**RUSSELL GAP**  
**PROJECT: 157329**

**LOCATION: NEAR RUSSELL GAP ROAD AND MOUNT OLIVE CHURCH ROAD**  
**TYPE OF WORK: AS - BUILT PLAN**

**Redlines are sealed by Kathleen M. McKeithan PE028432.**

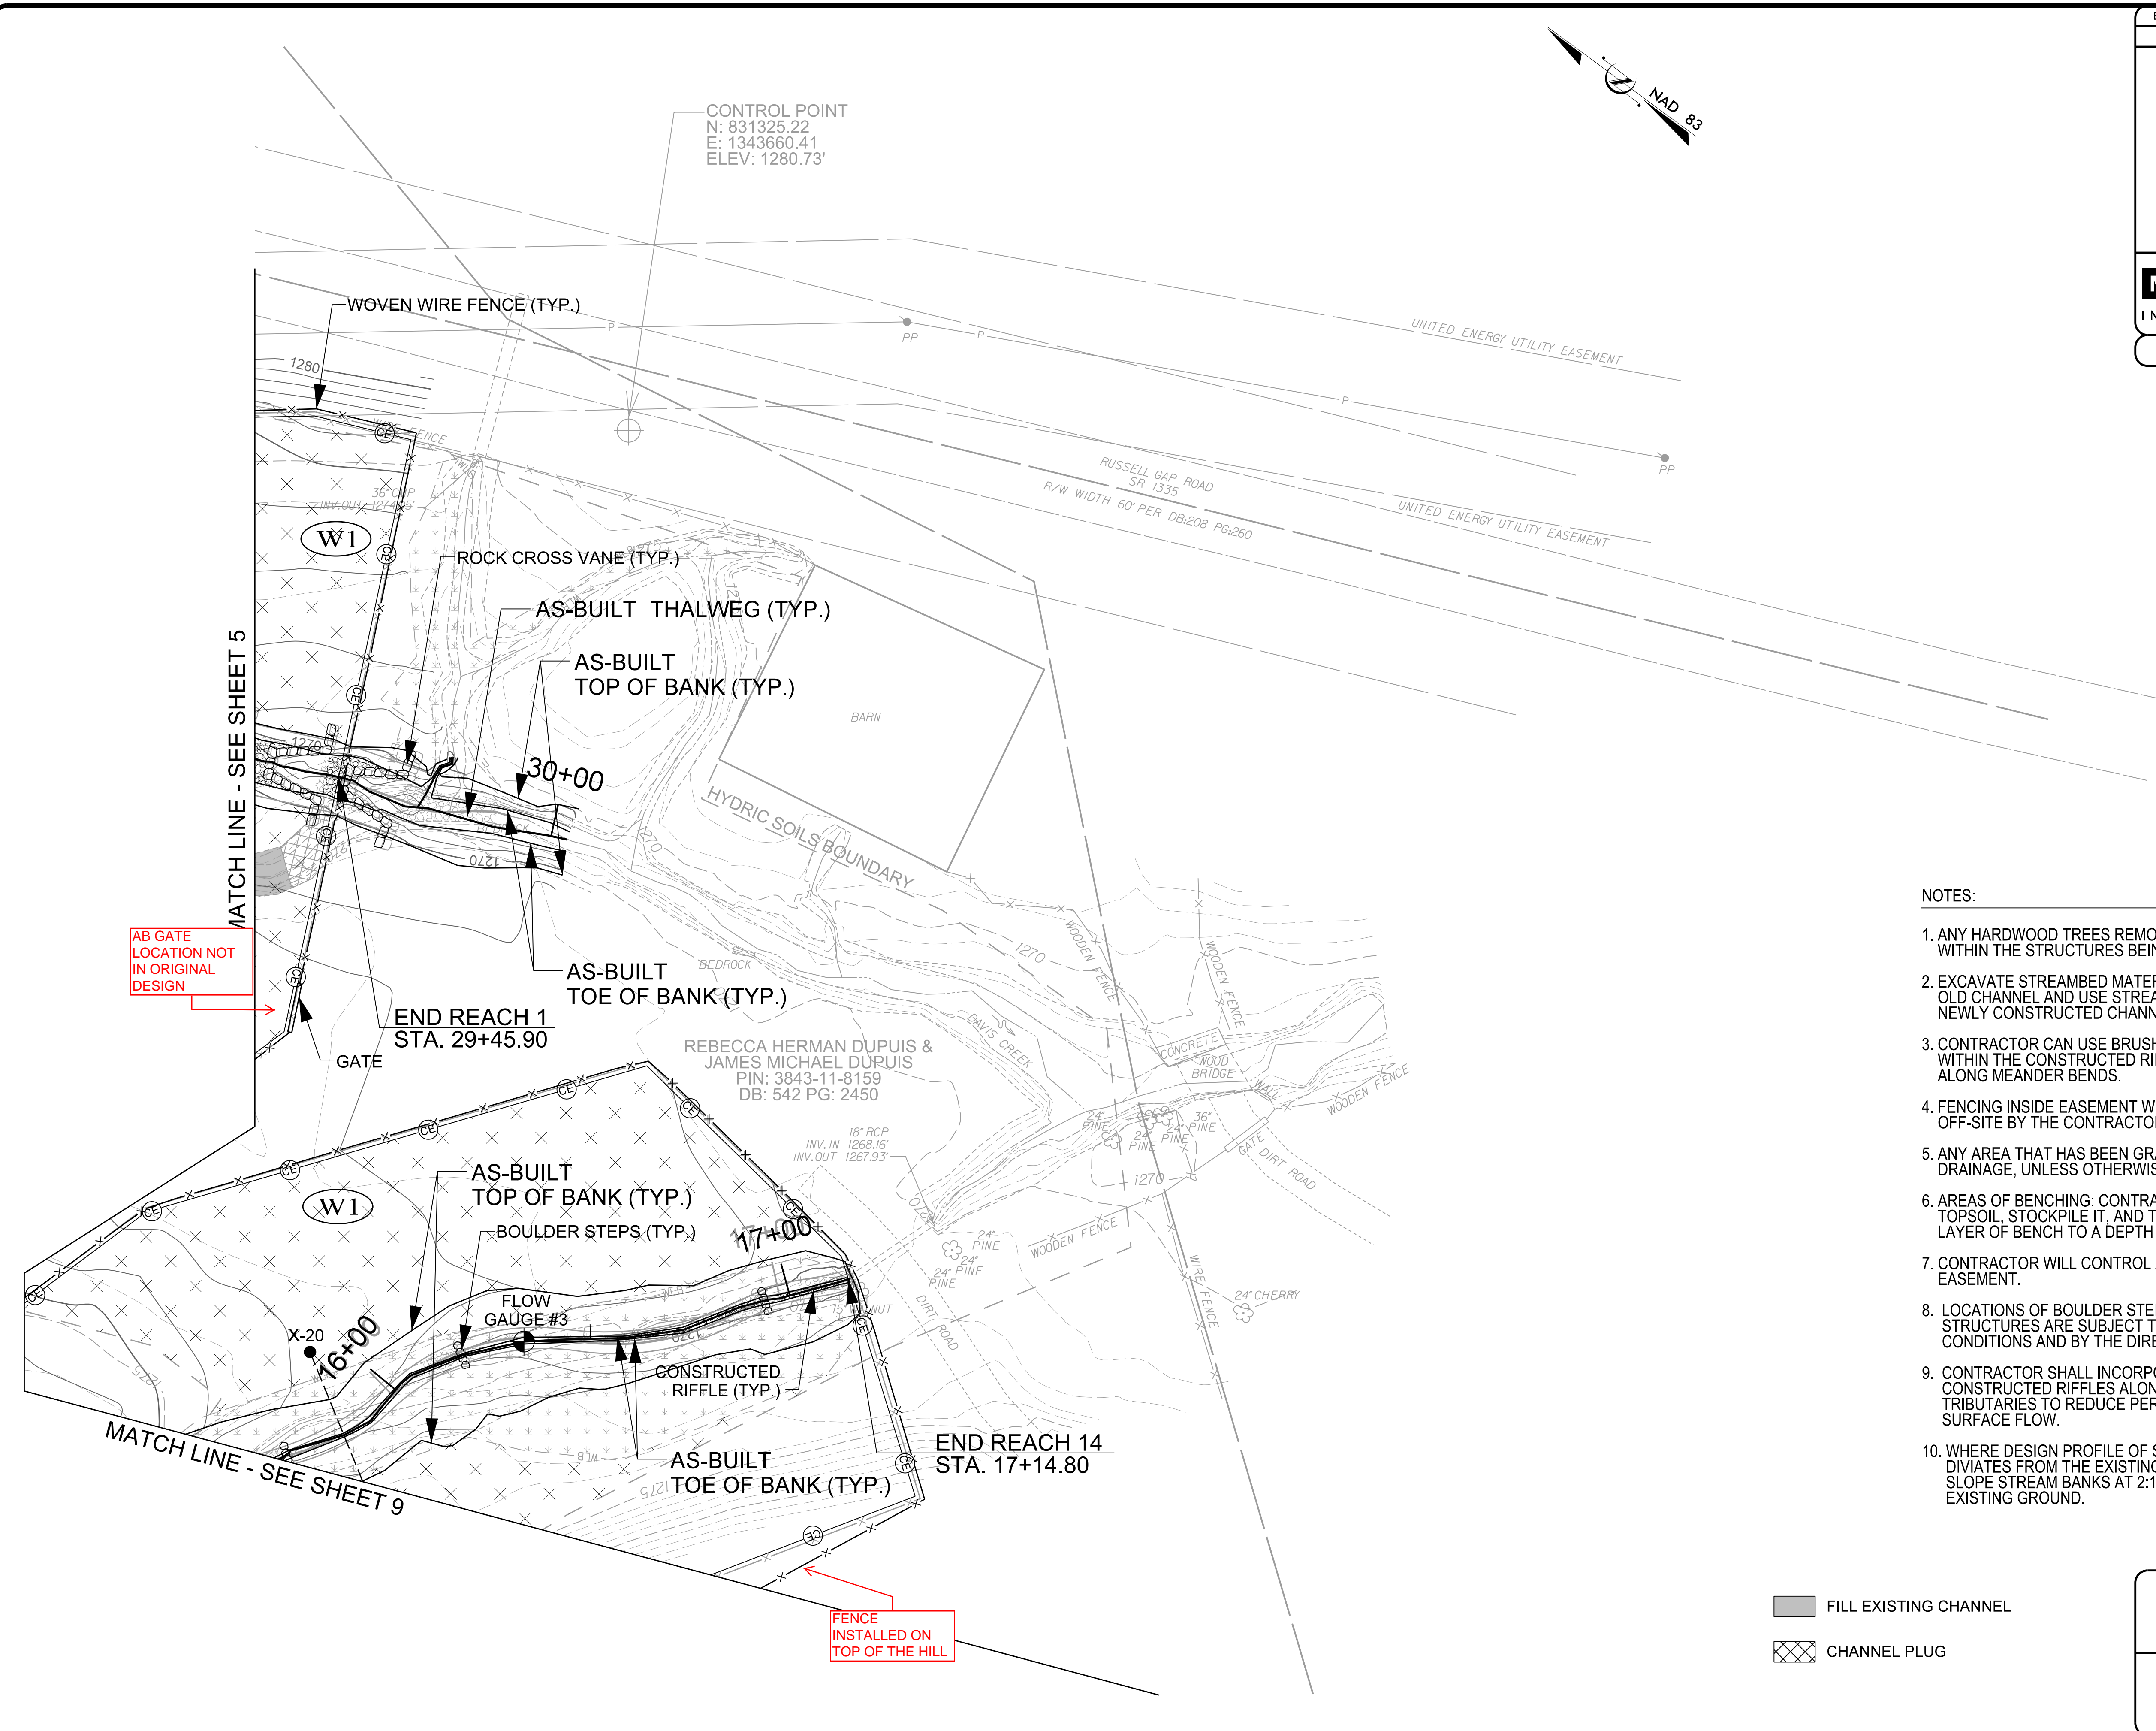
AB GATE LOCATION NOT IN ORIGINAL DESIGN

FENCE INSTALLED ON TOP OF THE HILL

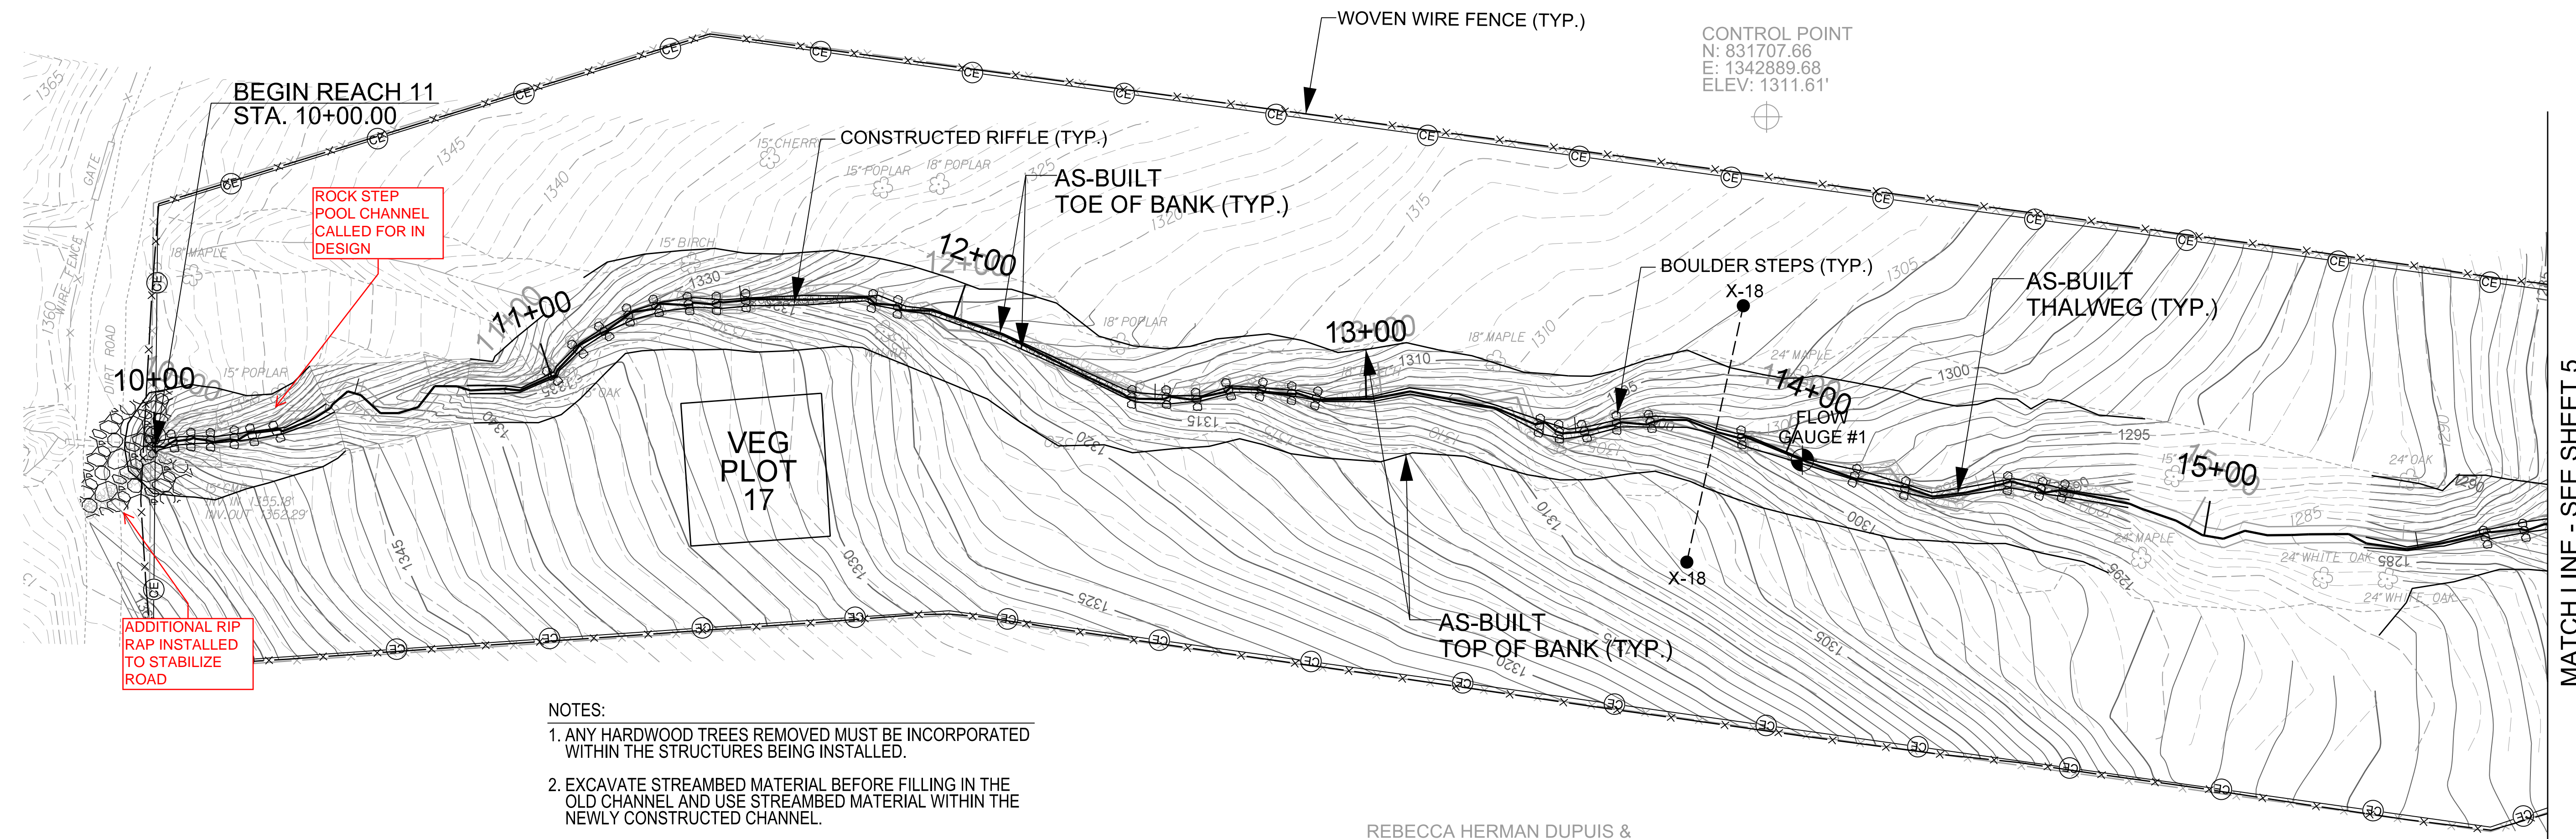
ROCK STEP  
POOL CHANNEL  
CALLED FOR IN  
DESIGN

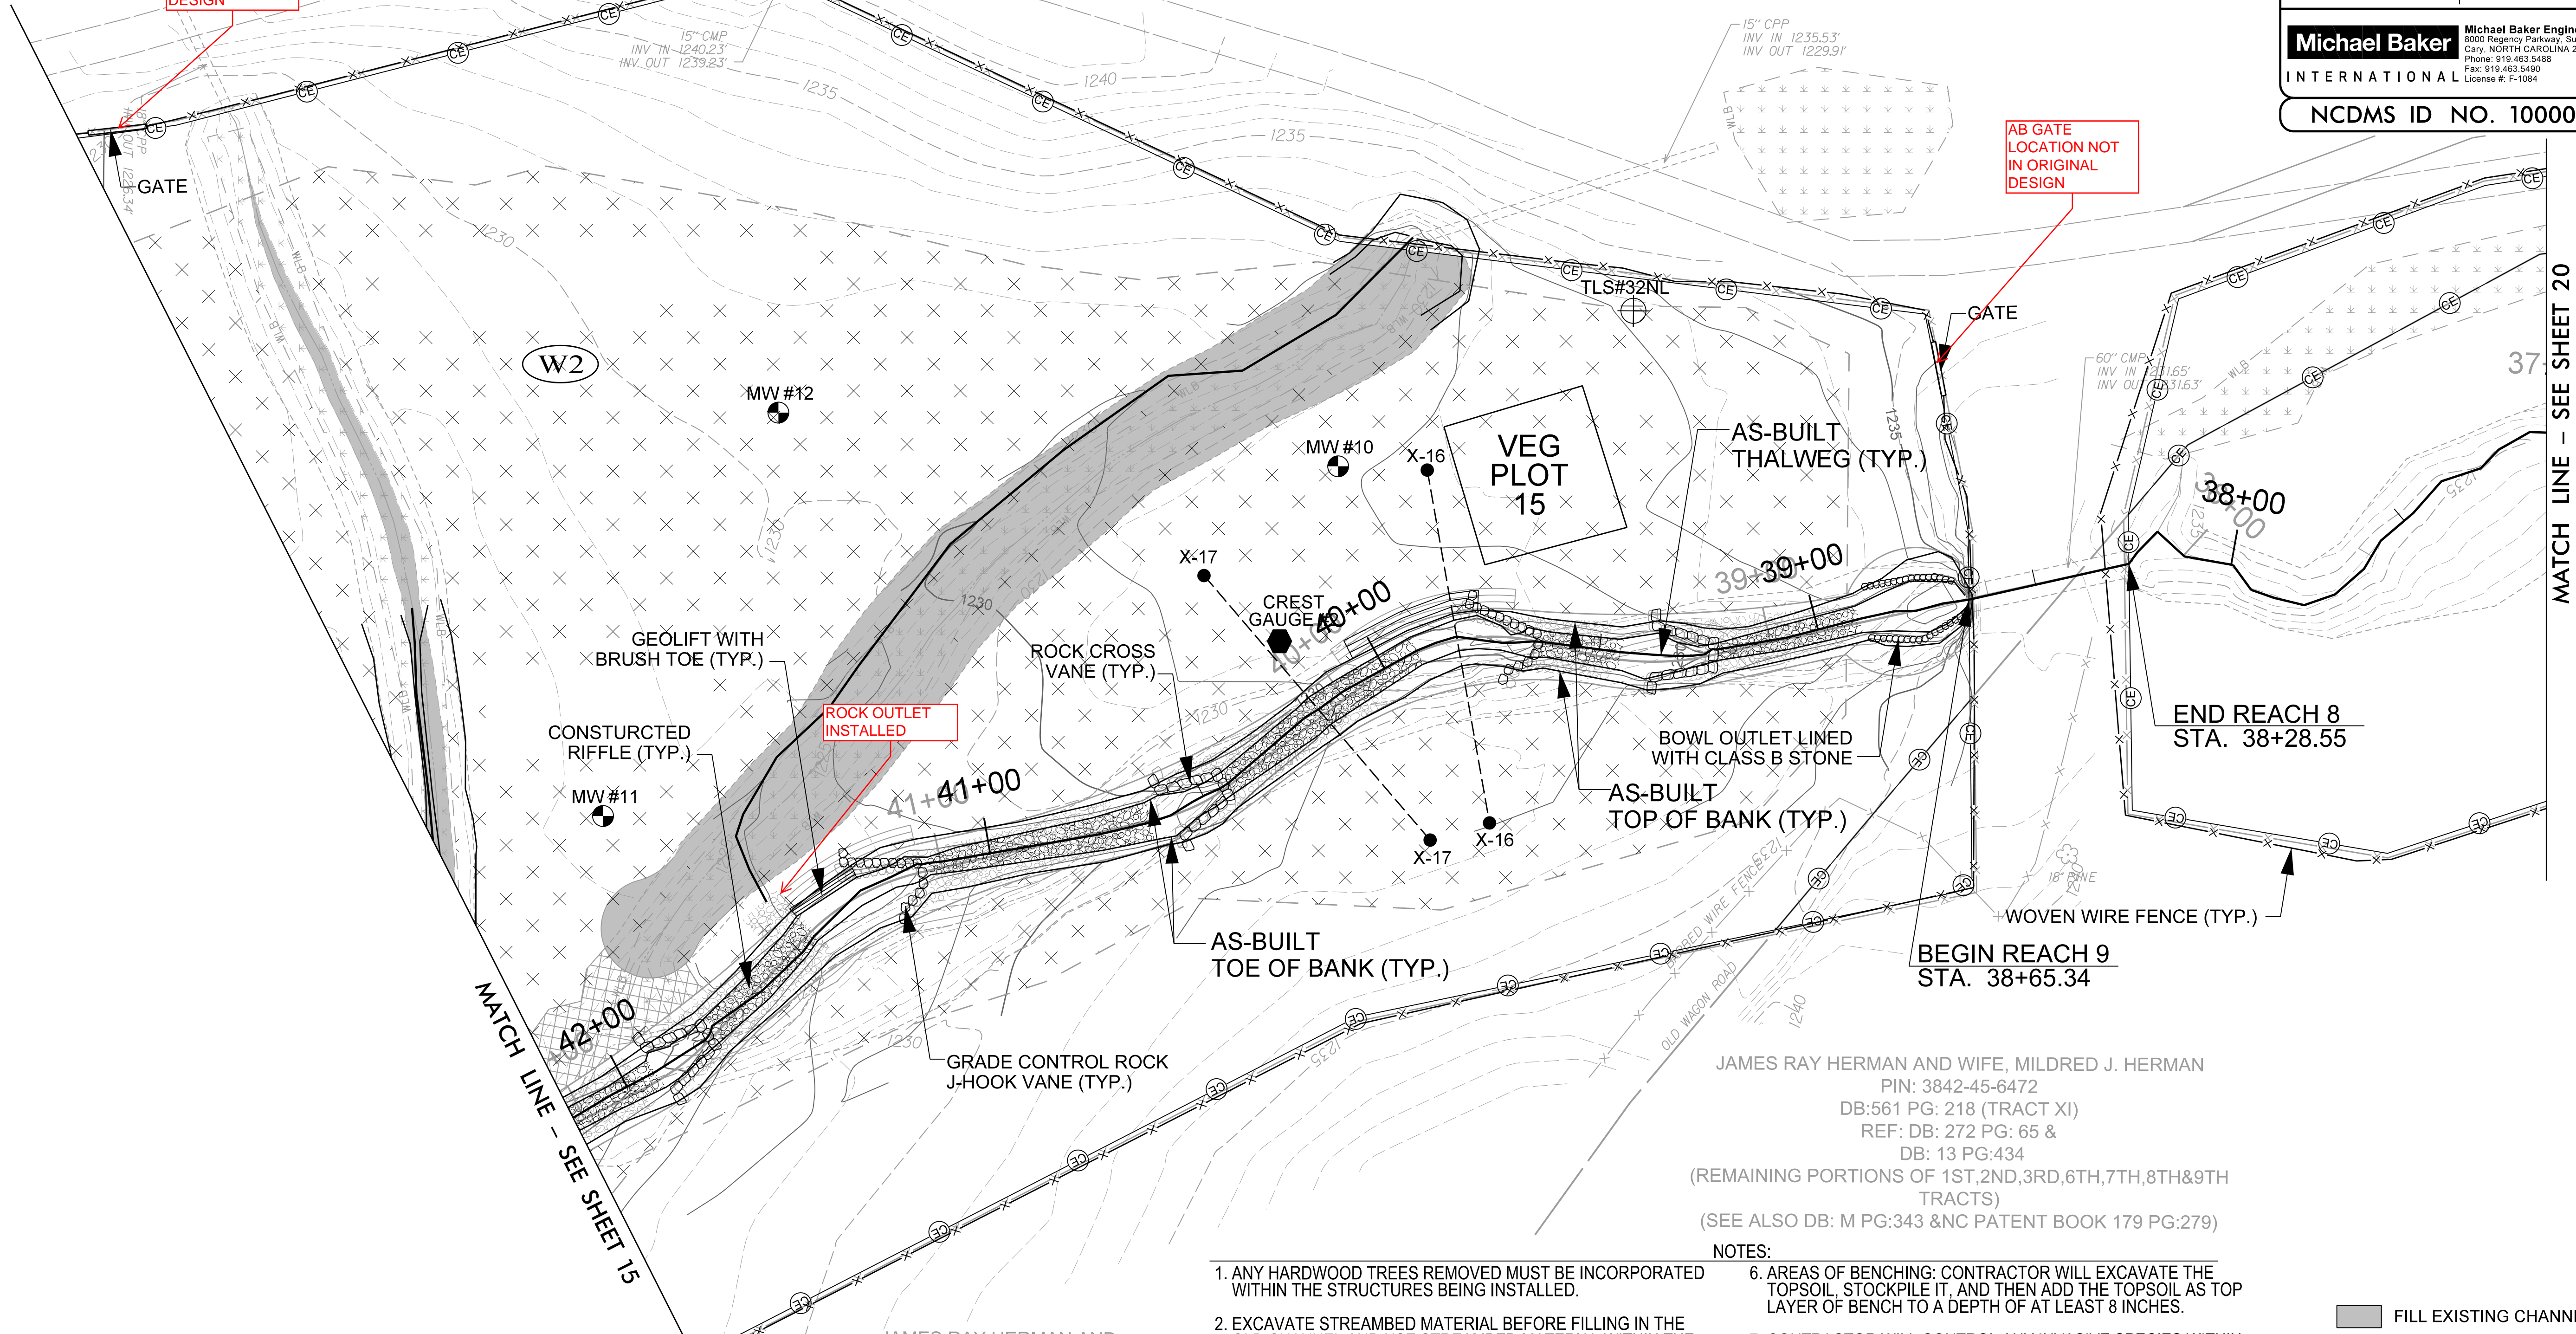
AB GATE  
LOCATION NOT  
IN ORIGINAL  
DESIGN

AB GATE  
LOCATION NOT  
IN ORIGINAL  
DESIGN
